Advanced LIGO Engineering Change Request (ECR)

ECR Title: ECR: Add black glass panels to the OMC Suspension Assembly to mitigate stray light noise

DCC No: E1500042-v1

See the attached design concept drawing.

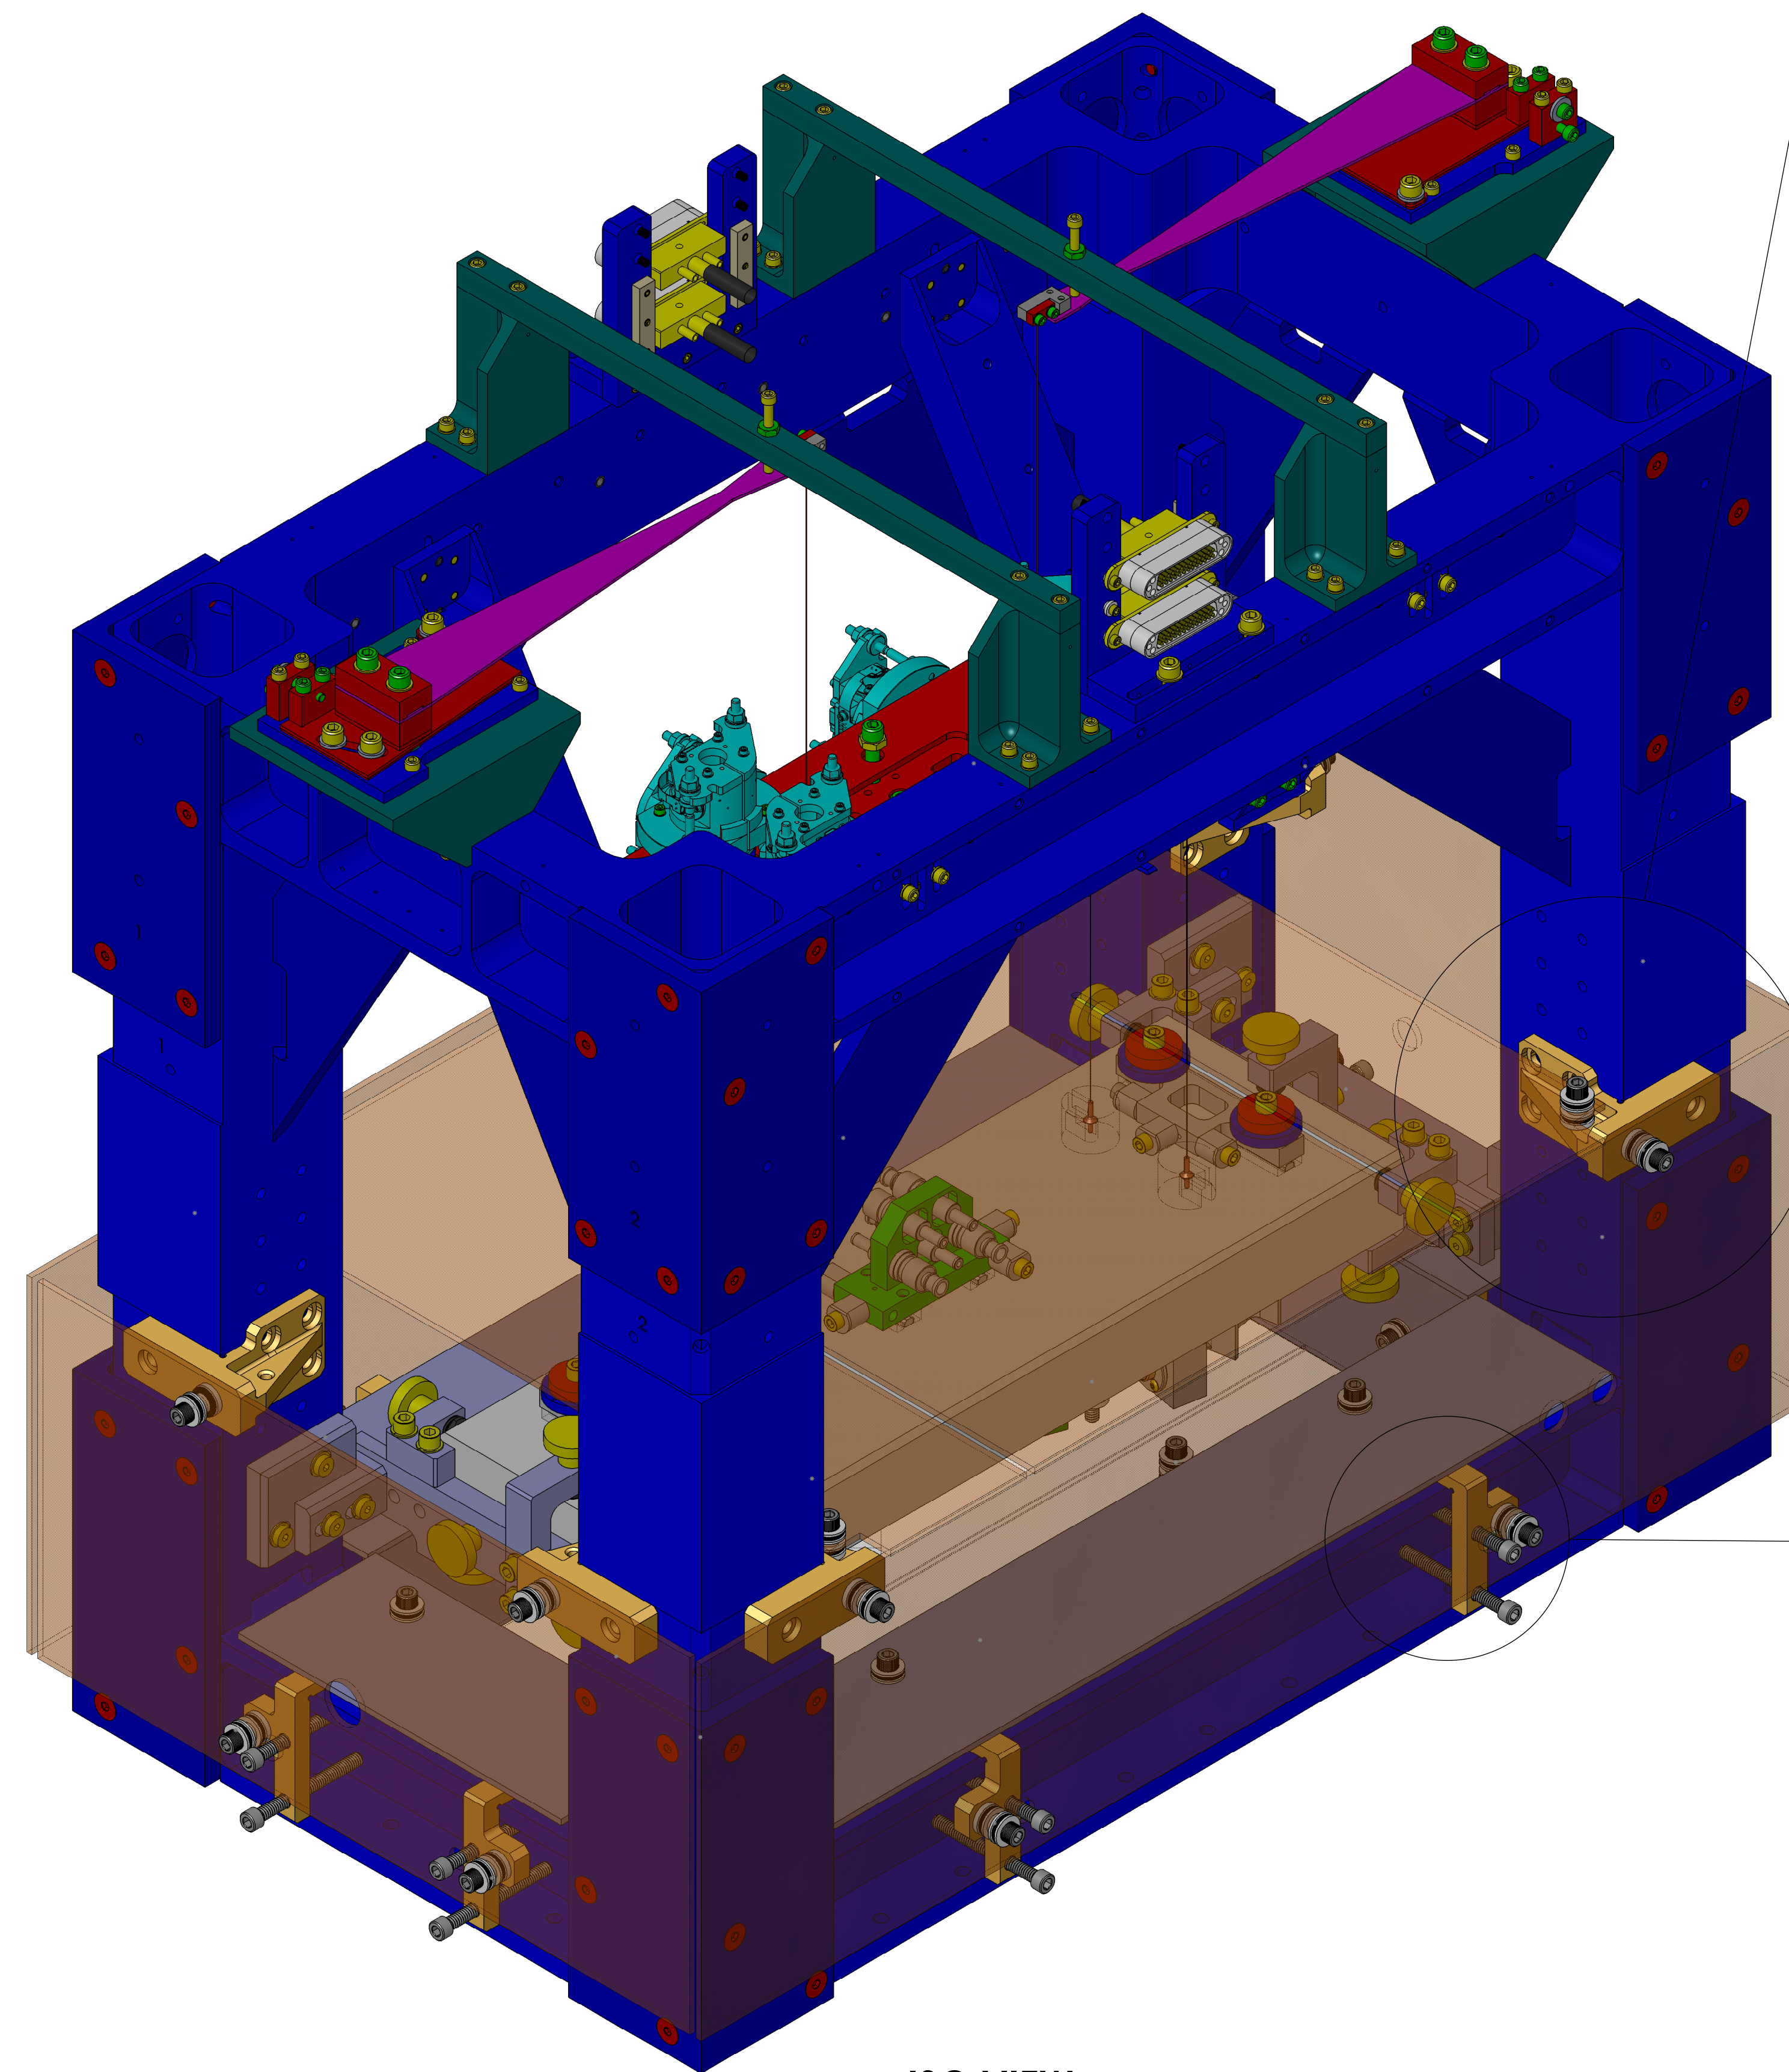
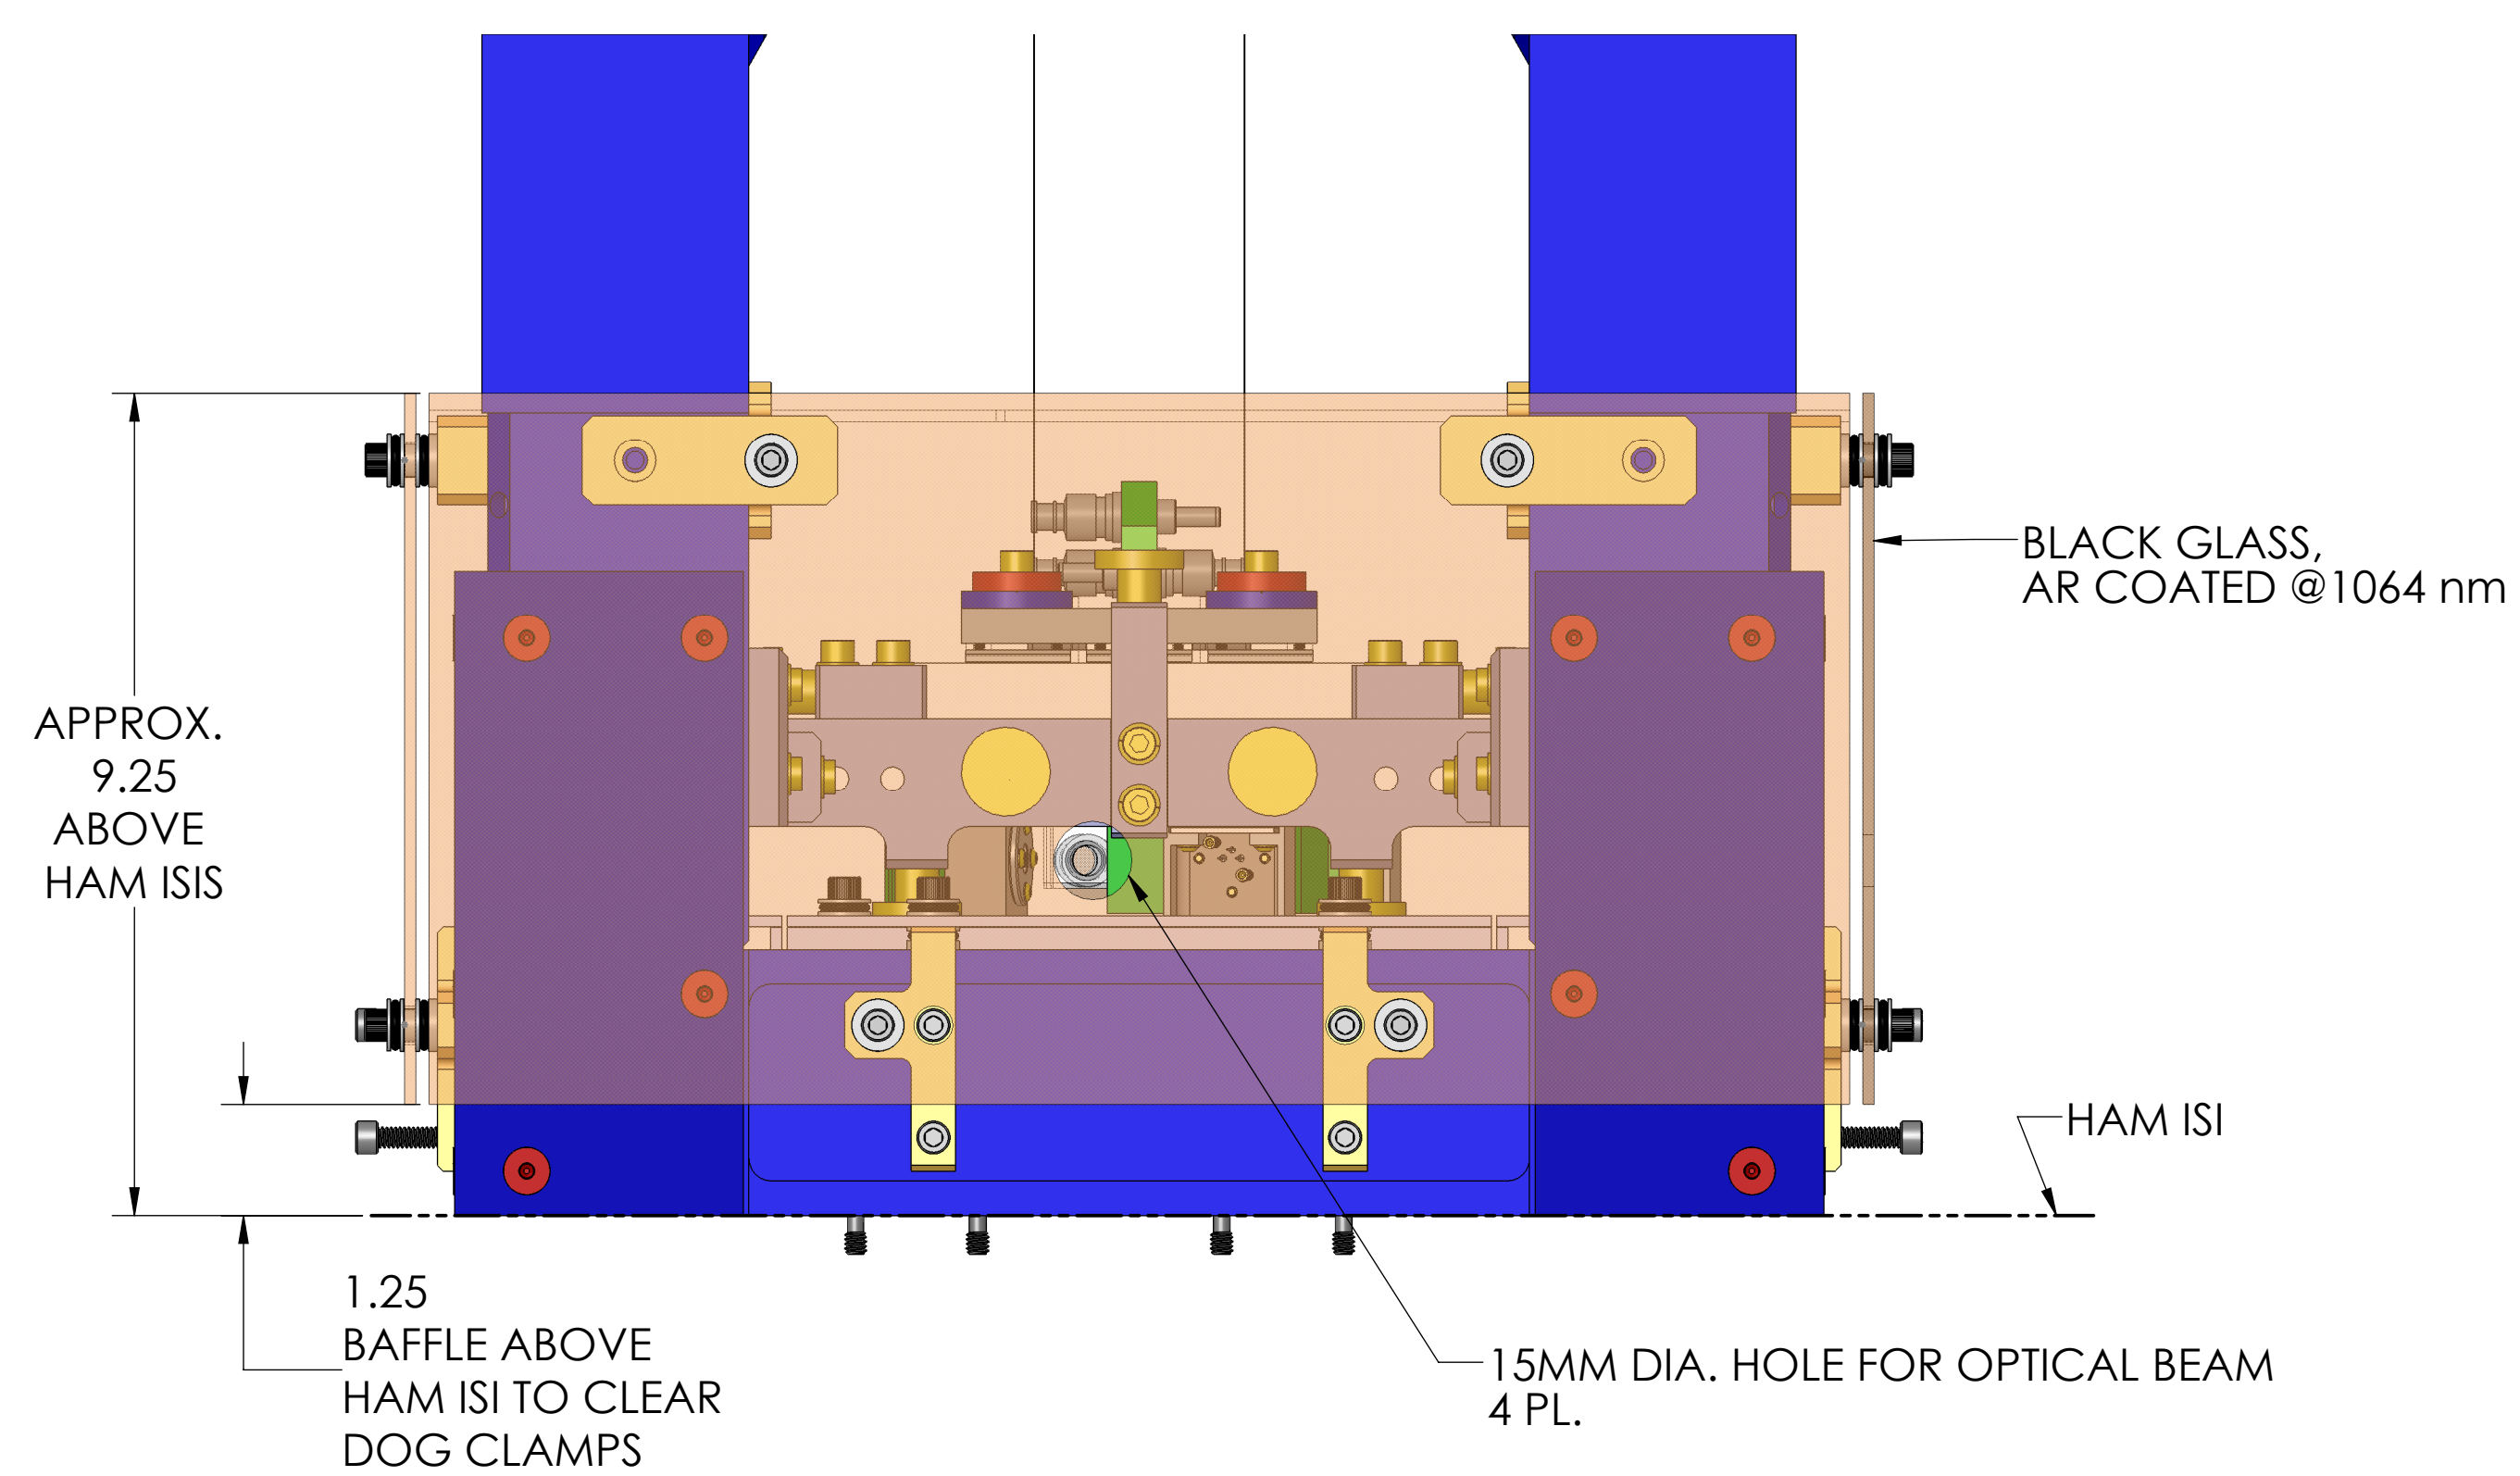
Description of Proposed Change(s): Attach AR-coated black glass panels to the OMC suspension structure (and to the optics table beneath the OMC suspension) in order to surround and isolate the OMC from scattering paths to/from the vacuum enclosure and the reflective metallic surfaces of the optics table and the OMC.

Reason for Change(s): DARM noise has been shown to increase when acoustic noise is increased/generated around the HAM6 chamber, implying a path for scattered light noise to/from the OMC involving the HAM6 vacuum enclosure surfaces (chamber walls, viewports and/or septum plate). It is reported in LLO elog #16255 that our current DARM noise (in the frequency range 70 to 400 Hz) might be limited by scattering from HAM6:

BLK GLASS (TOP)
ATTACHED TO TOP MT. BRACKET
VIA 1/4-20 CAPTIVE SCREW
(SEE HARDWARE STACK-UP DETAIL, FOR REFERENCE)
